Access Compliance Report

Public Rights-of-Way

(Curb Ramps)

Intersection ID: 49276	Main Street: HOMECOMING_WY	Cross Street: REUNION_ST	Location: SE
ADA ID: B4695D316DB3	Ramp Type: PerpDiag	Initial Pass/Fail: Fail	Overall Compliance: No
Severity Score: 12.5			
Codes/Mitigation Info/Possible Solution		Field Measurements/Component Compliance

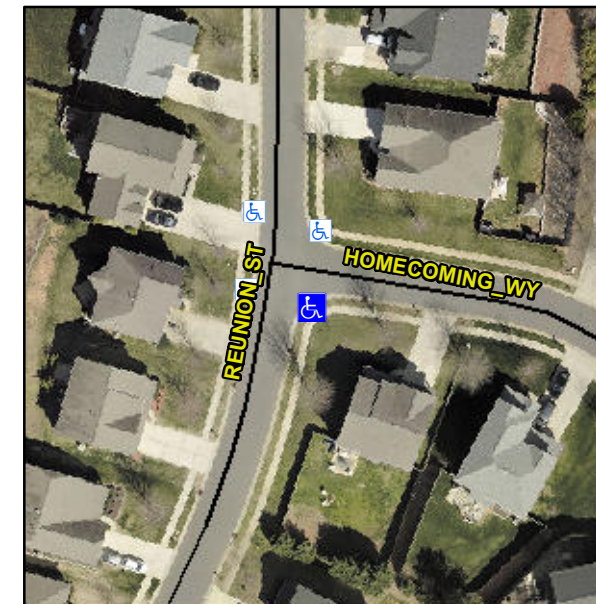
Not Found, R304.2.2

Compliance	Description	Data	Compliance	Description	Data
N/A	Ramp Length (in)	46.5	No	Ramp Slope (%)	8.9
Yes	Ramp Width (in)	48.3	Yes	Ramp XSlope (%)	1.1
N/A	Flare Type LT	N/A	N/A	Flare Type RT	N/A
N/A	Flare Slope LT (%)	N/A	N/A	Flare Slope RT (%)	N/A
N/A	Flare Traversable LT?	N/A	N/A	Flare Traversable RT?	N/A
N/A	Landing Length (in)	N/A	N/A	DWS Provided?	N/A
N/A	Landing Width (in)	N/A	N/A	DWS Contrast?	N/A
N/A	Landing Slope (%)	N/A	N/A	DWS Length (in)	N/A
N/A	Landing X Slope (%)	N/A	N/A	DWS Full Width?	N/A
N/A	Landing Curb? (Y/N)	N/A	N/A	DWS Offset (in)	N/A
N/A	Shared Landing?	N/A			
N/A	Gutter Ponding?	N/A	N/A	Gutter Slope (%)	N/A
N/A	Gutter Lip Ht (in)	N/A	N/A	Gutter X Slope (%)	N/A
N/A	Painted X Walk1?	No	N/A	Painted X Walk2?	No
	X Walk 1 Direction	To NE		X Walk 2 Direction	To NW
N/A	X Walk 1 Width (in)	N/A	N/A	X Walk 2 Width (in)	N/A
	X Walk 1 Slope (%)	0.8		X Walk 2 Slope (%)	0.8
	X Walk 1 X Slope (%)	2.2		X Walk 2 X Slope (%)	2.2

Remove & Replace Curb Ramp With Two New Directional Ramps or Equivalent.
